Ogg.: **"HD 900" FRIGGITRICI, SOSTITUZIONE LIMITATORI DI TEMPERATURA.**

Obj.: **"HD 900" FRYERS, SAFETY THERMOSTATS REPLACEMENT.**

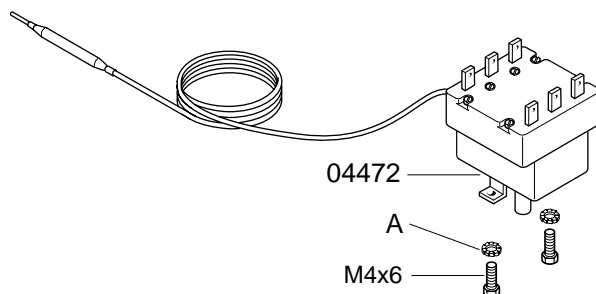
FRIGGITRICI ELETTRICHE - Da matricola 901....., il vecchio limitatore a codice 59559 è stato sostituito dal nuovo a codice 04472.

L'intercambiabilità è possibile, utilizzando due viti "M4x6" con rondelle dentate "A" come da figura e collegando elettricamente il limitatore, seguendo le indicazioni dei riferimenti da abbinare riportati nella tabella sottostante.

ELECTRIC-HEATED FRYERS - From serial number 901..... onwards, the old thermostat 59559 has been replaced by the new code 04472.

The new part is interchangeable with the old one by using two "M4x6" screws with toothed washers (see reference "A" in the picture here below) and connecting the electric wires as described in the table underneath.

Rif. cavo Ref. cable	Rif. limitatore Ref. thermostat
1	11
2	12
